AMENDMENT OF SOLICITATION/MODIFICATION OF CONTRACT				1. CONTRACT ID CODE		PAGE OF PAGES 1 2	
2. AMENDMENT/MODIFICATION NO. 0003		3. EFFECTIVE DATE 30-Sep-2022		4. REQUISITION/PURCHASE REQ. NO.		5. PROJECT NO.(If applicable)

Summary of changes for Amend - 0003
McNary Powerhouse Drainage, Unwatering, and Equalization System Rehabilitation
W912EF22R0015

MCNARY LOCK AND DAM
COLUMBIA RIVER, OREGON AND WASHINGTON
POWERHOUSE DRAINAGE, UNWATERING AND
EQUALIZATION SYSTEM REHABILITATION

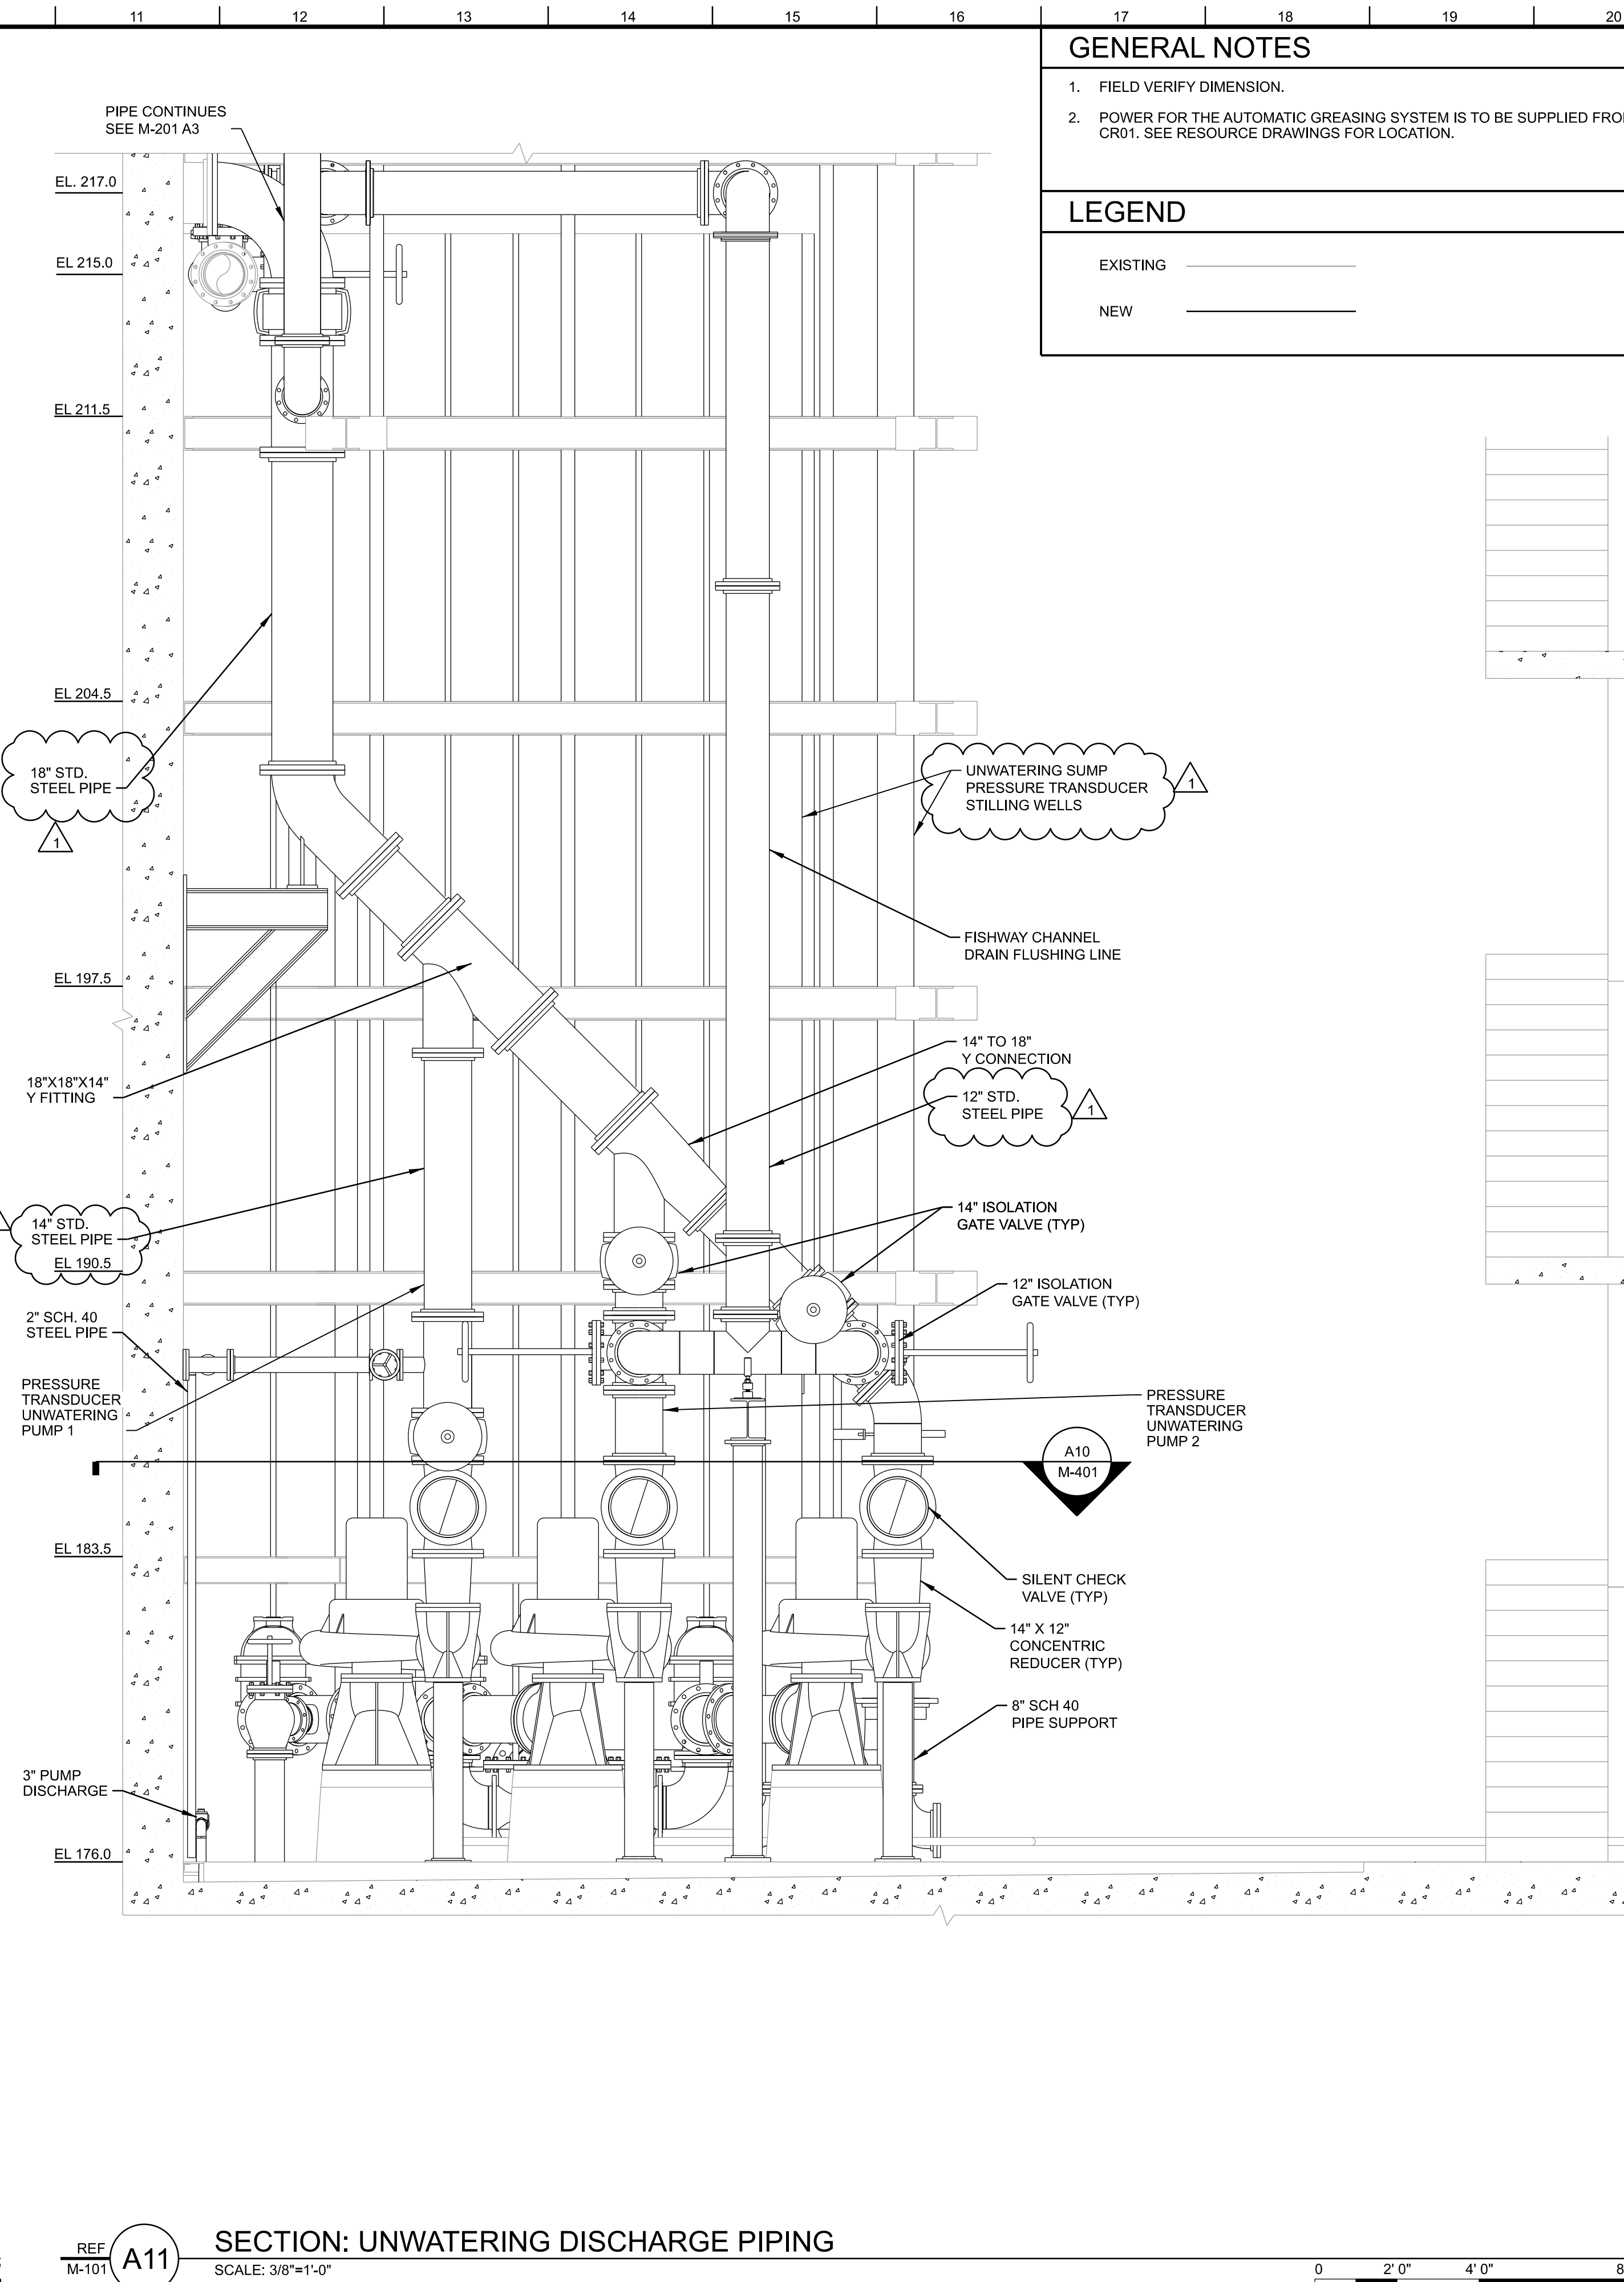
- Added Paragraph 2.3.11 "Drainage Header Clean Out"
2. Revised the following Drawings (See clouded areas for revisions).
 - a. SHEET SD101
 - b. SHEET M-101

Finish Smoothness of exposed concrete for ~~the sump pump access as all~~ concrete cutting shown on drawing ~~S-101~~ SD101 to broom finish smoothness.
